DATE: September 9, 2026

SUBJECT: Addendum No. 1 to the Bidding Documents for:

Mehlville School District – Bus Transportation Facility Project

1 ELECTRICAL SITE PLAN - DEMOLITION
1" = 60'-0"

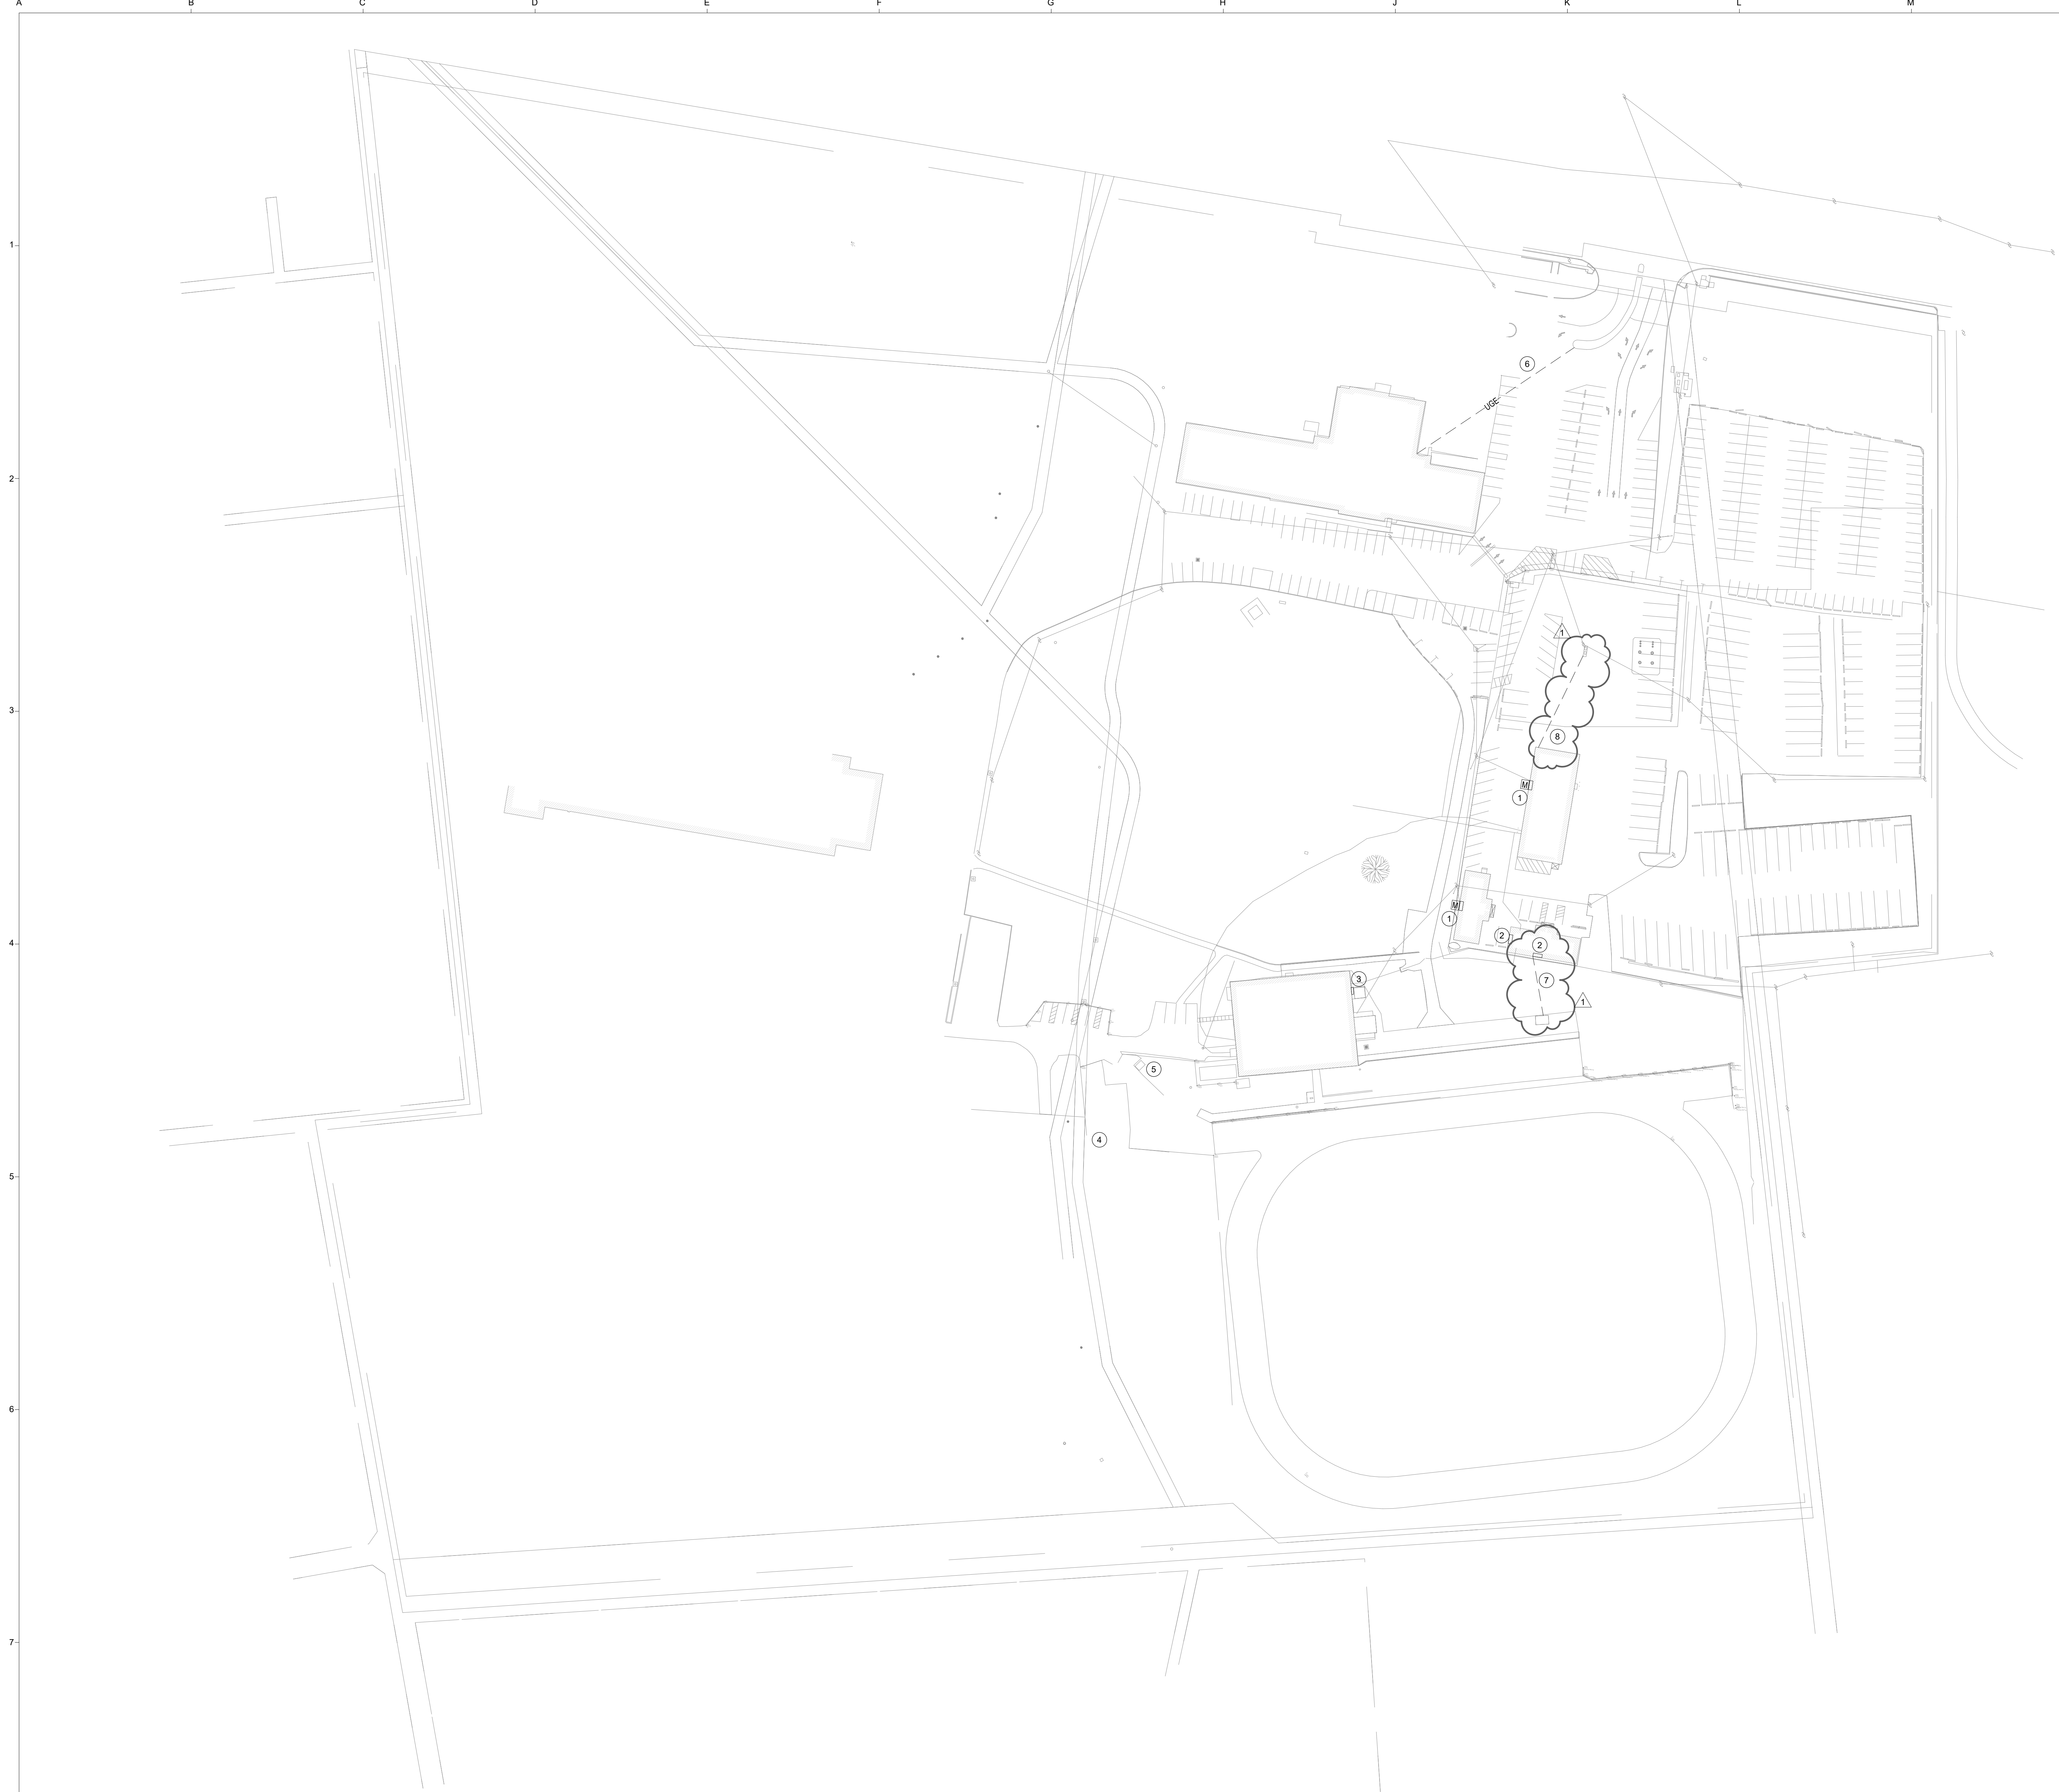
7. Sheet ES101 – Electrical Site Plan – Demolition

- a. **ADDED** to scope demolition of underground electrical feeding storage shed and fuel pumps.
- b. **ADDED** keynotes 7 and 8 to clarify the removal of underground electric.

- 7 DEMOLISH UNDERGROUND ELECTRICAL FEEDING STORAGE SHED ONCE MOBILE BUILDING ELECTRICAL IS DISCONNECTED.
- 8 DEMOLISH EXISTING POWER AND CONTROLS FOR FUEL PUMPS AND TANKS TO EXTENTS FEASIBLE FOR RECONNECTION IN NEW WORK.
